CITY OF PLANO COUNCIL AGENDA ITEM

Subject: Appeal of the Heritage Commission's denial of a Certificate of Appropriateness to replace existing 6 1/2" exposure, drop style, 3/4" thick wood siding with 6 3/4" exposure, 5/16" thick, "Custom Colonial", smooth finish HardiePlank lap siding at front (north) and both side (east and west) elevations of the structure located at 808 E. 18th Street.

Certificate of Appropriateness: 808 E. 18th Street

Attachment C

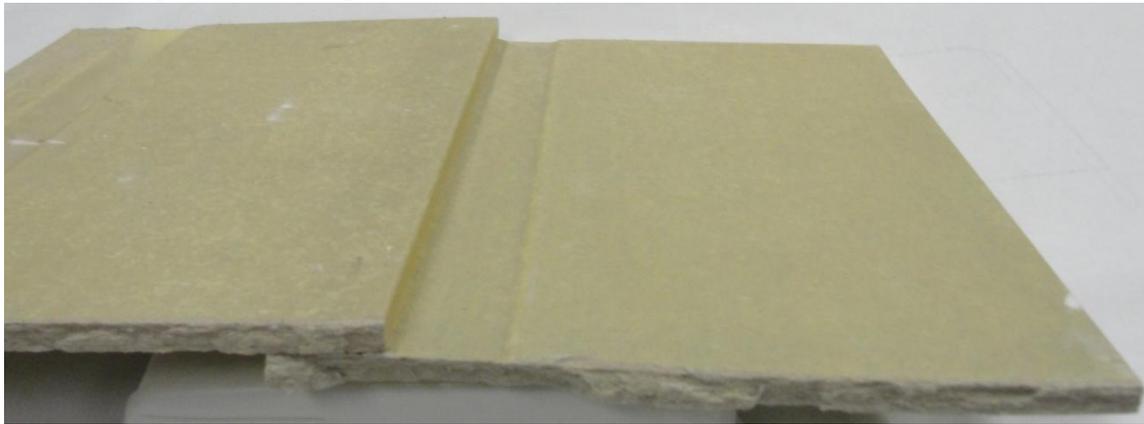
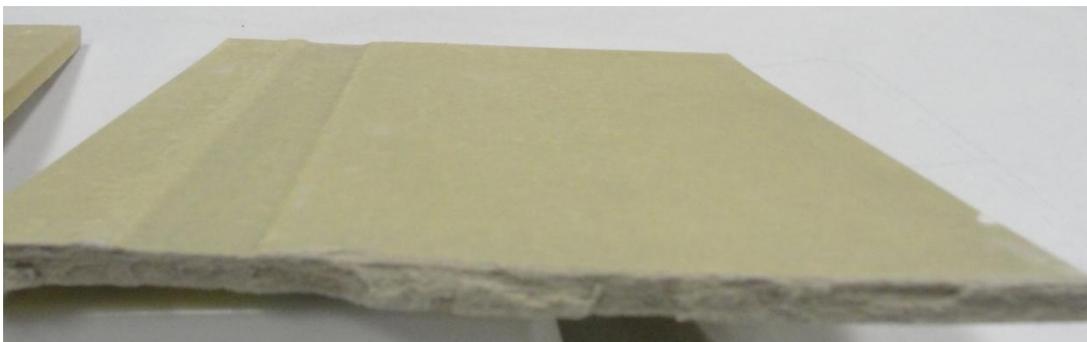
1. The proposed HardiePlank siding does not match the existing wood siding in size, exposure, style, profile, and finish. Therefore, it fails to meet Section 4.1.b of Haggard Park Heritage District Guidelines (see Attachment C).
2. The building is currently being rehabilitated with a new roof, new replacement doors and windows, and new exterior trims. The proposed siding replacement at all elevations would result in losing most of the exterior historic fabric.
3. Replacing existing good condition wood siding with inappropriate HardiePlank siding at front and side elevations would fail to meet Section 4.3, 4.5, and 4.10 of Haggard Park Heritage District Design Guidelines.

- Restore existing 6 1/2" exposure, drop style, wood siding at front (north) and both side (east and west) elevations. Repair using salvaged wood siding from the rear elevation and, if necessary, replace to match existing siding in material, size, exposure, and profile.
- Remove and salvage existing wood siding at rear (south) elevation. Install new 5/16" thick, "Custom Colonial", smooth finish, HardiePlank siding at rear (south) elevation (unprotected facade) only.
